PORTLAND HARBOR RI/FS

**APPENDIX H**

**EPA REVIEW OF EXISTING AND HYDRODYNAMIC AND  
SEDIMENT TRANSPORT MODEL**

**FEASIBILITY STUDY**

**Figure H2-1a. Comparison of Measured and Predicted Changes in Sediment Bed Elevation on a SDU Basis**

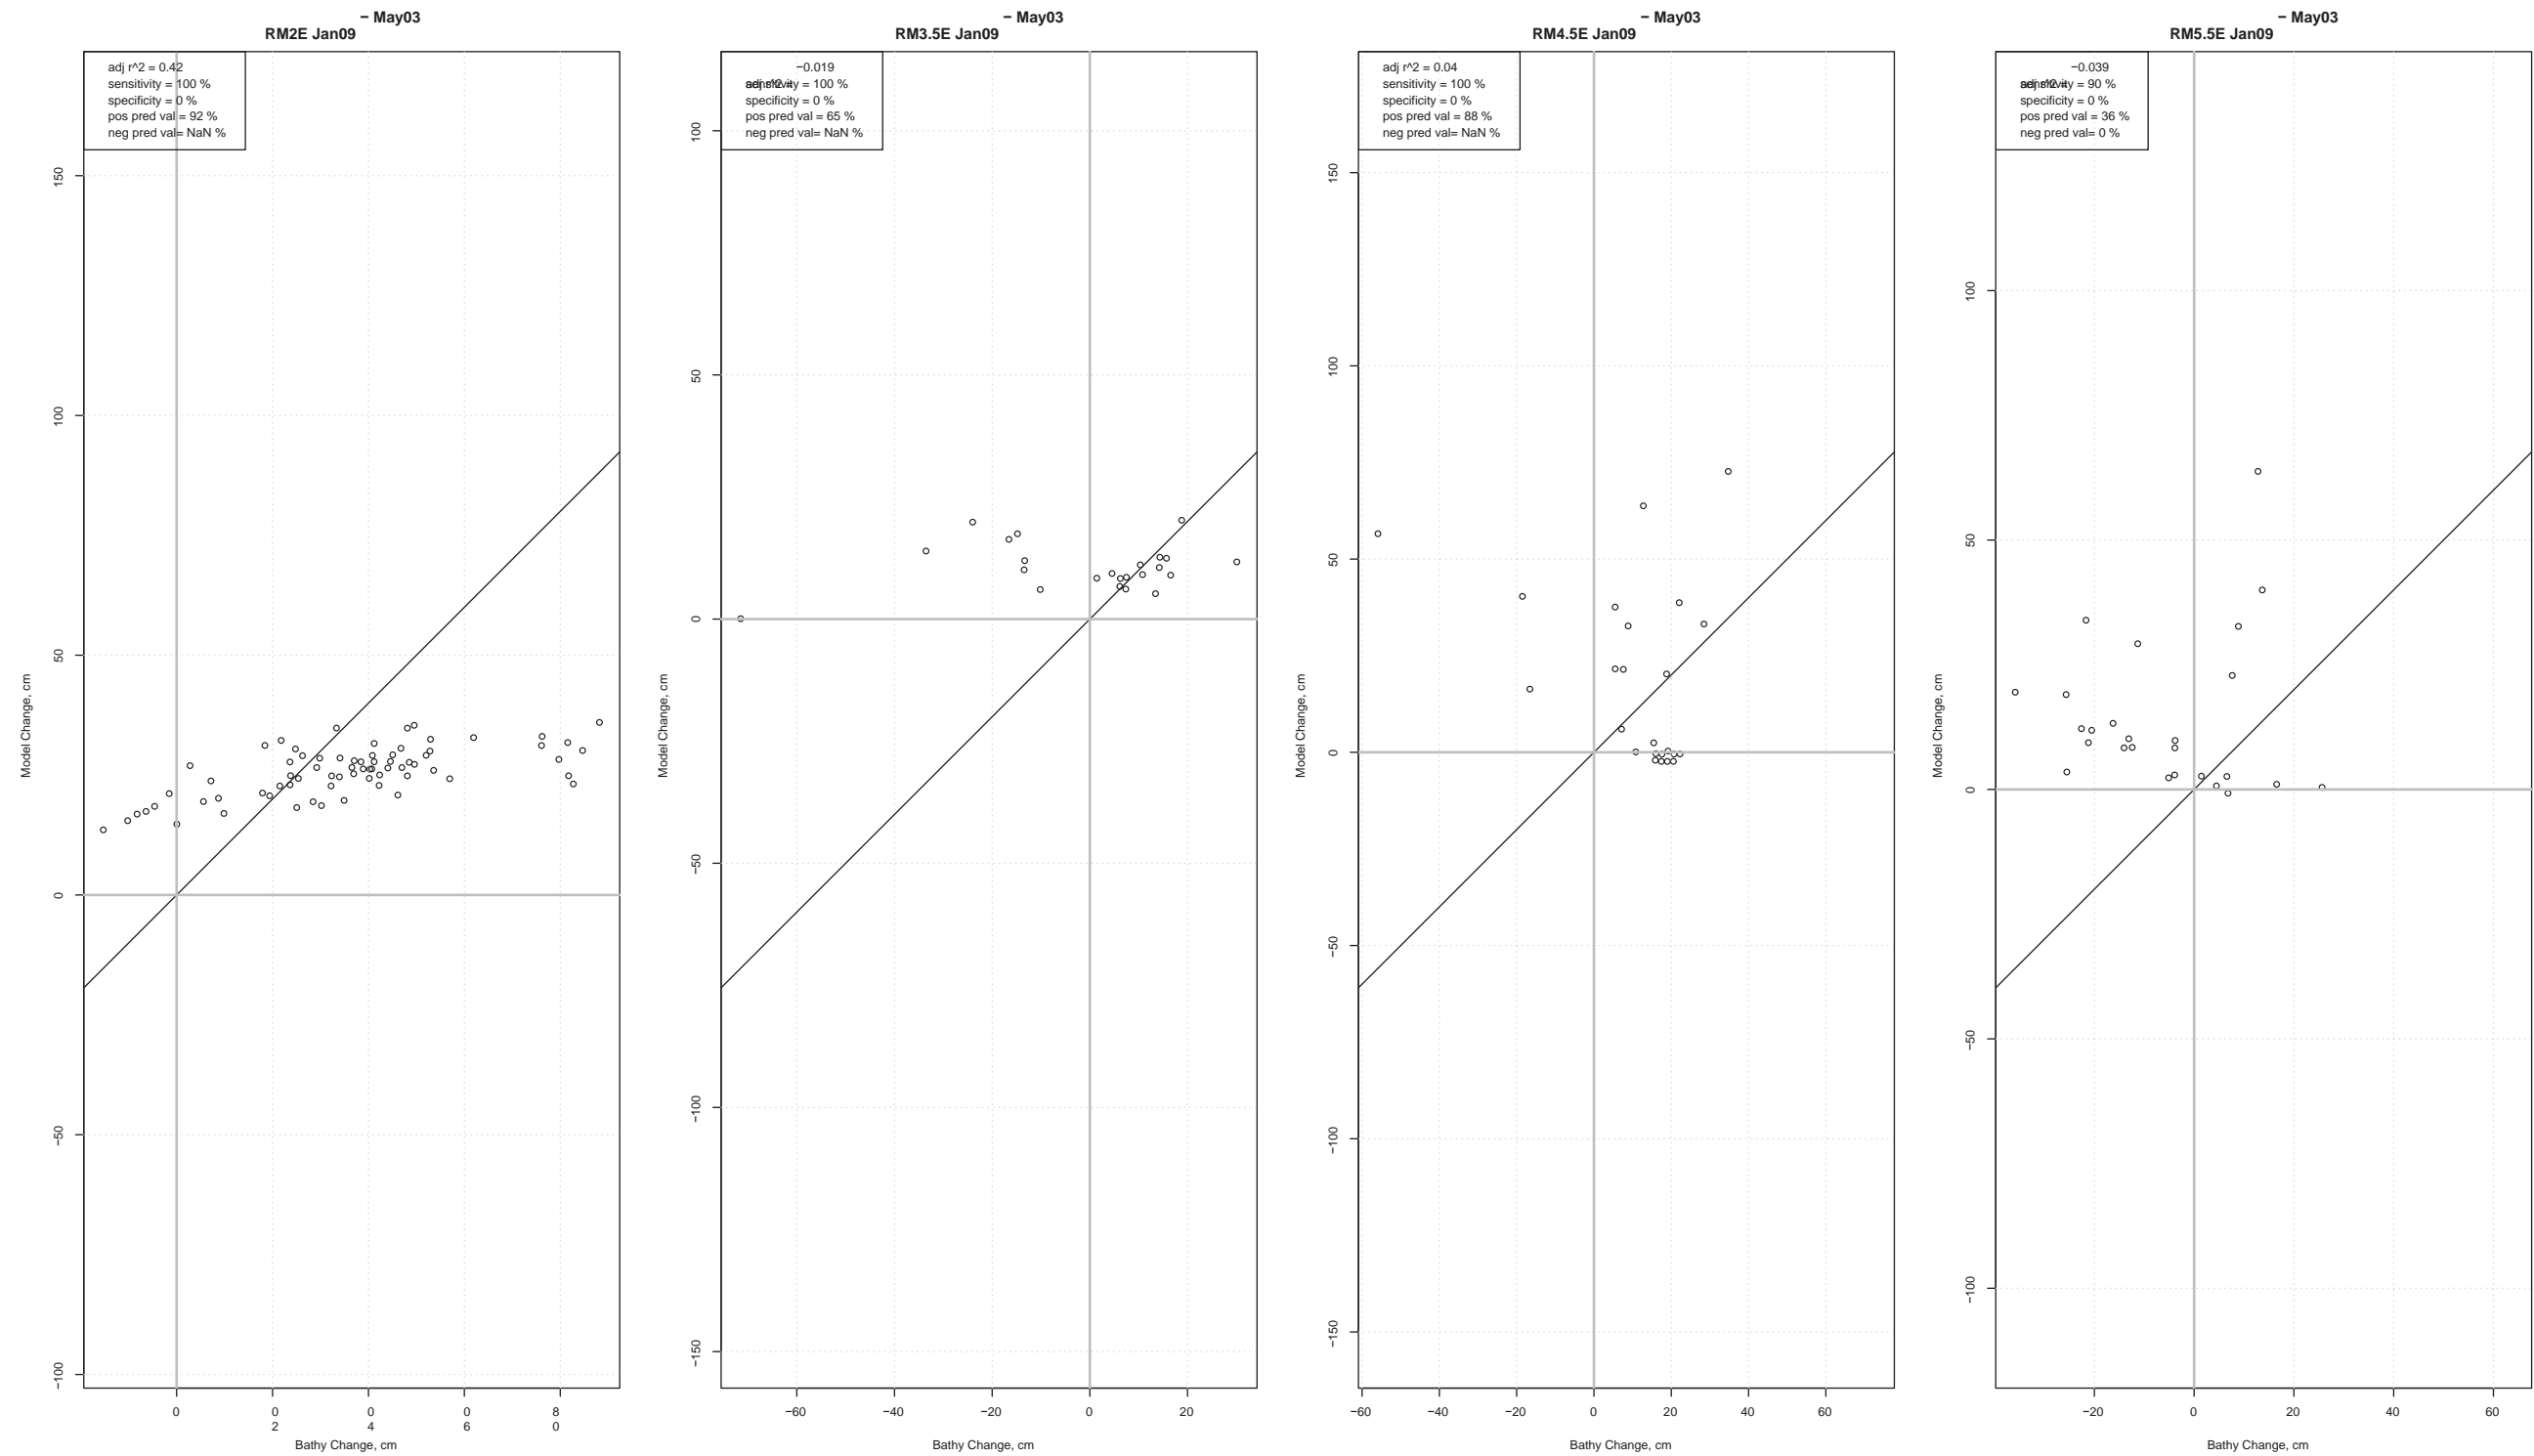
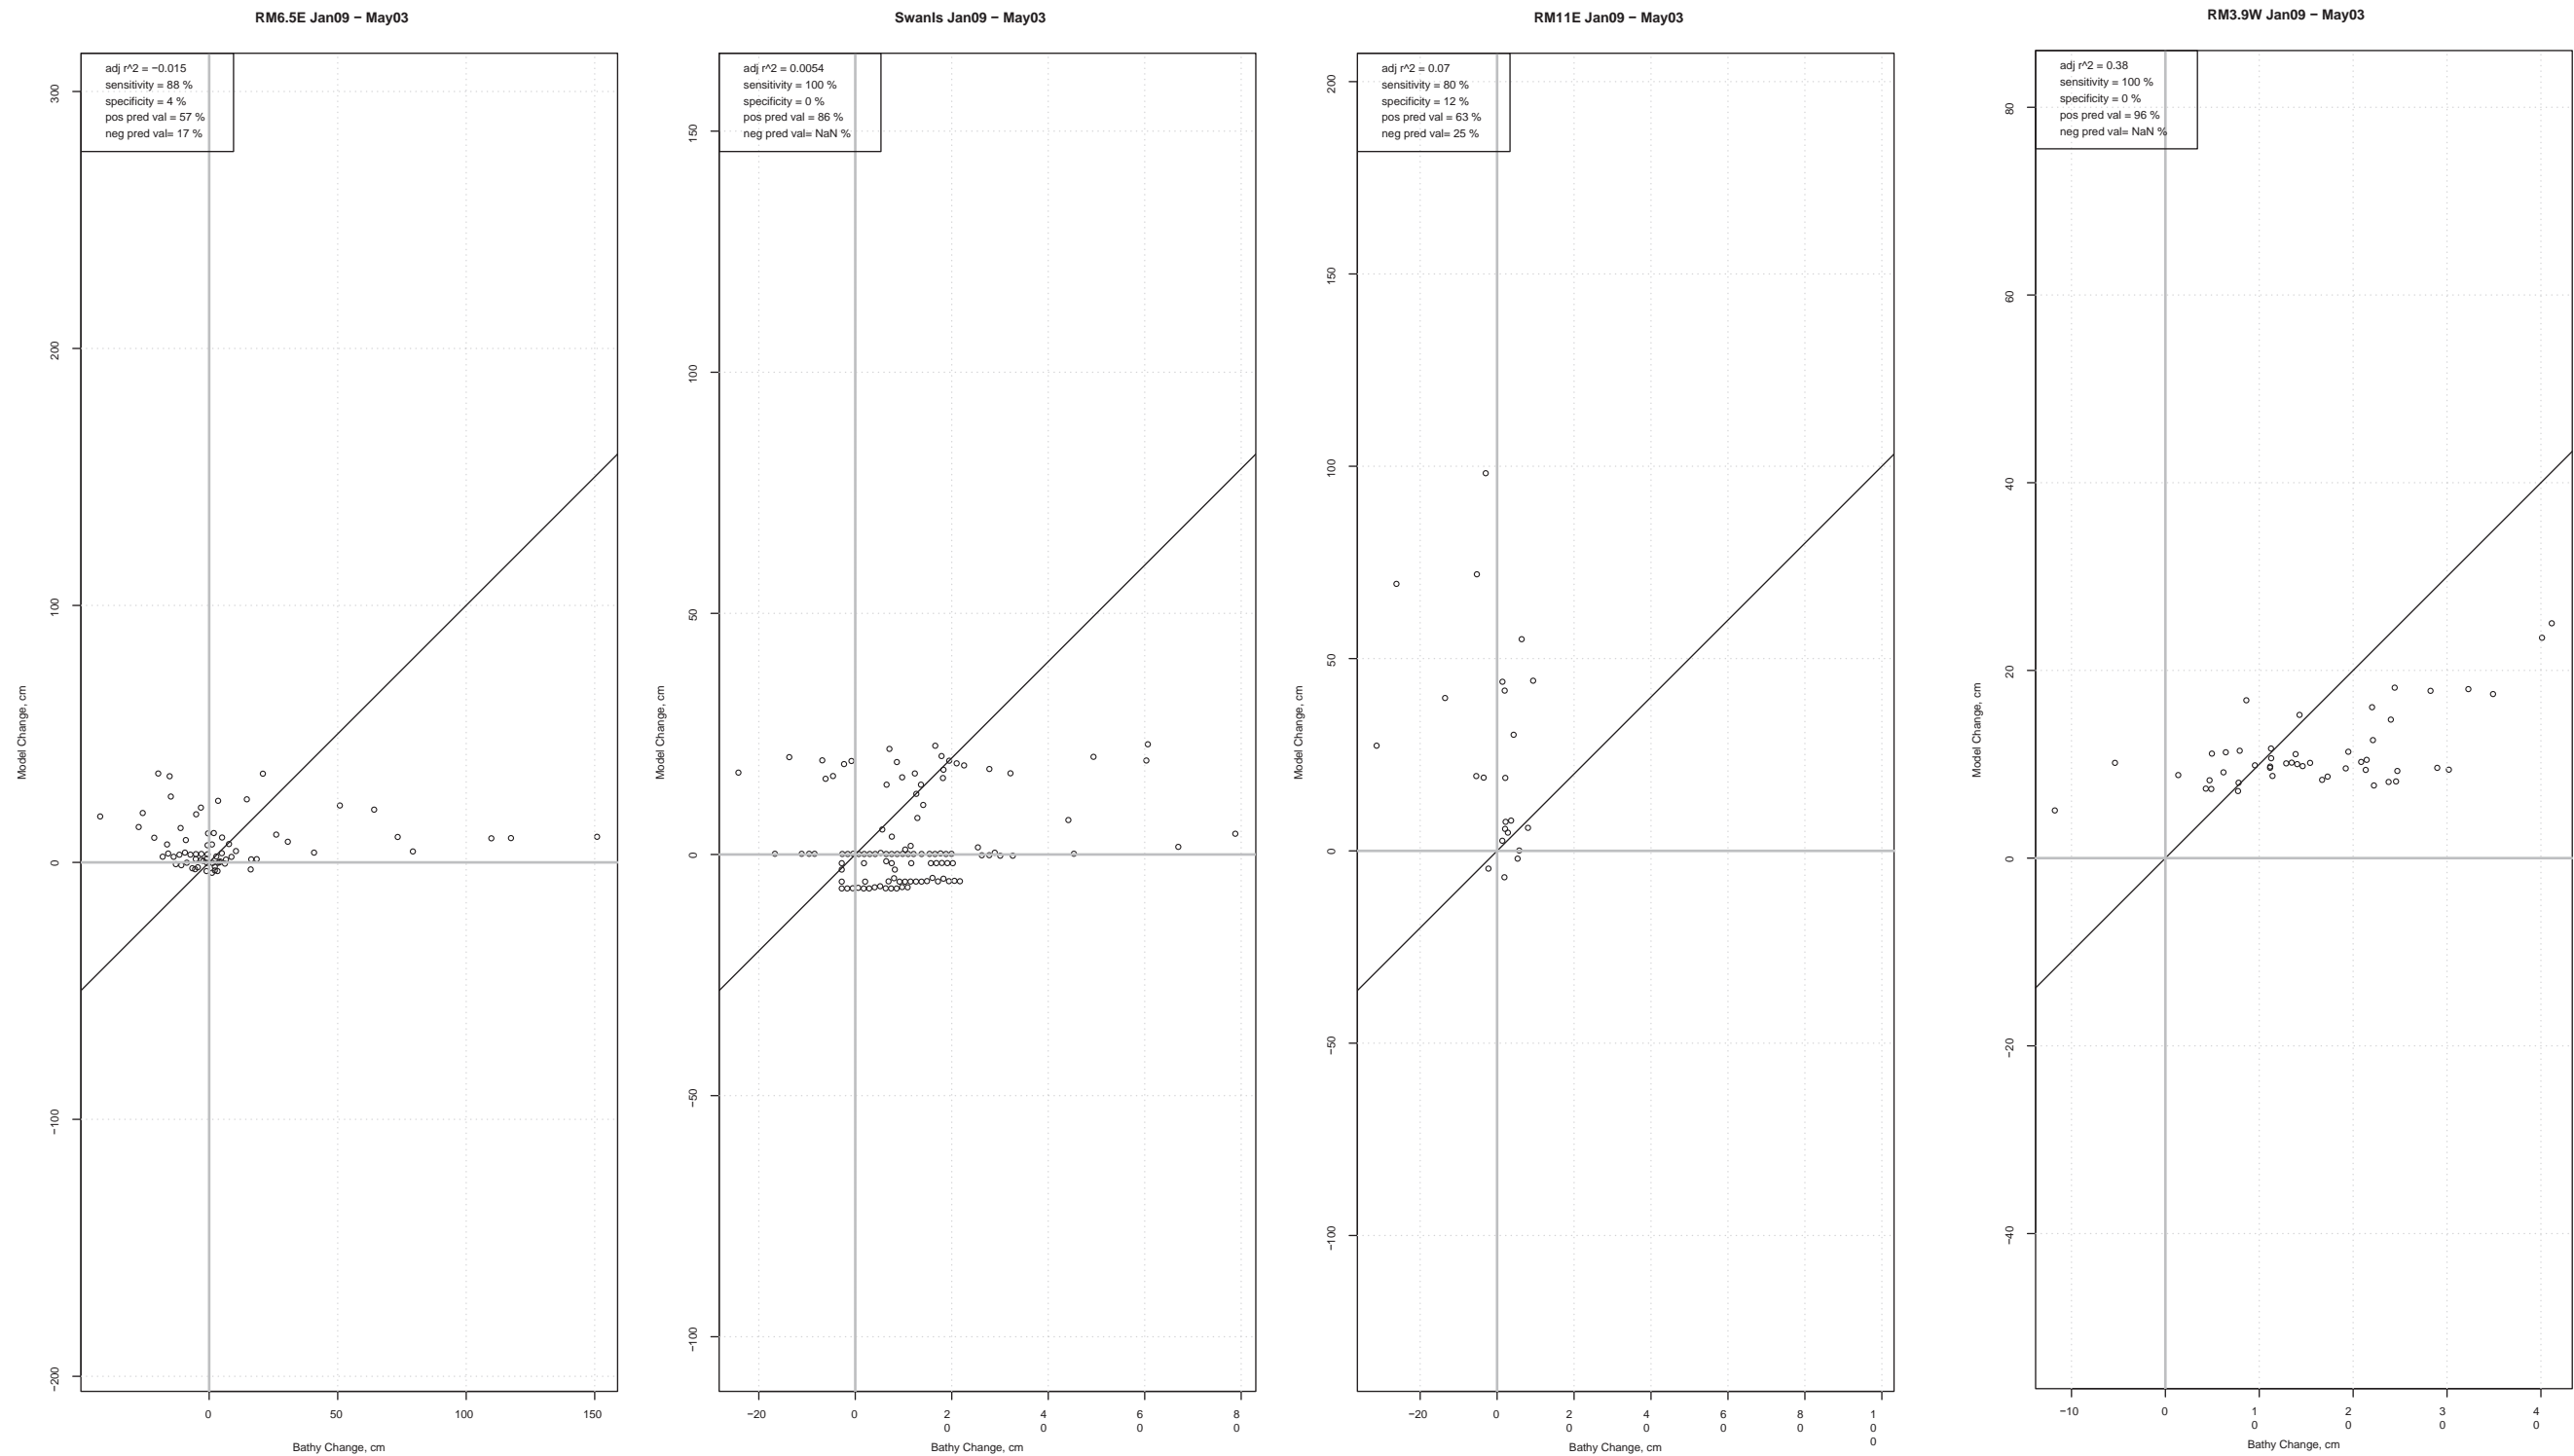
This evaluation indicates that the model predicts deposition the majority of the time. Erosion is predicted only within SDUs RM 5.5E, RM 6.5E, RM11E and RM6 Nav. However, measured changes in bathymetry indicate that some erosion was observed within every SDU. In addition, the plots did not correlate well with the 1:1 line which would indicate a good correlation between predicted and measured changes in sediment bed elevation. Adjusted  $r^2$  values range from 0.0028 to 0.42 with an average  $r^2$  of 0.093. SDU RM 2E ( $r^2 = 0.42$ ) and RM 3.9W ( $r^2 = 0.38$ ) exhibited the best correlation between measured and modeled results. Although deposition is under-predicted in some SDUs as evidenced by a greater number of points below the 1:1 line (RM 2E, Swan Island, RM 3.9W, RM 5W, RM 6W, RM 6NAV, and RM 7W), this is a result of the magnitude of the predicted deposition in comparison to the magnitude of the measured deposition. Only in SDUs RM 5.5E, RM 6.5E, RM 11E and RM 6Nav does the model predict erosion when deposition is observed (lower right quadrant). Conversely, the model predicts deposition when erosion is observed in every SDU.

These conclusions are supported by the positive and negative predicted values included **Figure H2-1**. Positive predictive values measures the percentage of positive predictions for which there actually was a positive response. In this case, the evaluation considers the percentage of time deposition was predicted when deposition was measured. Positive predictive values are greater than 50 percent - ranging from 57 percent to 97 percent - for all SDUs. However, the negative predictive power – which measures the percentage of time erosion was predicted when erosion was measured - is below 50 percent for all SDUs, with a maximum negative predictive value of 33 percent in SDU RM6Nav. As noted above, because the model failed to predict erosion in all but four of the SDUs, negative predictive values can only be calculated for 4 SDUs.

Overall, the results of this analysis suggest that the Portland Harbor HST model tends to over predict deposition, particularly in areas where erosion is measured. As a result, the utility of the contaminant fate and transport model developed for the Site to evaluate MNR is limited.
